Service bulletin

SB 42-13 / 01-06 Rev. 1

IKARUS C42 and C42B: Rudder pedal.

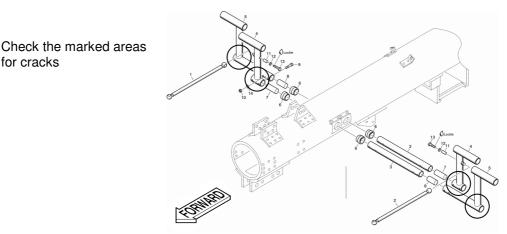
- 1. Check the welded joint at the base of the pedal for cracks according to the instructions given below.
- 2. Inclusion of this check in the normal 50 hour inspection.
- 3. If necessary, replace affected pedal.

for cracks

To carry out the inspection, release the pedal push-rods and, after checking the front side, fold the pedals towards the seat, in order to inspect the rear. If cracks are detected, the affected pedal must be replaced before the next flight.

After carrying out the inspection, the pedal push-rods must be re-attached to the pedals and secured. The work may be carried out be a gualified person.
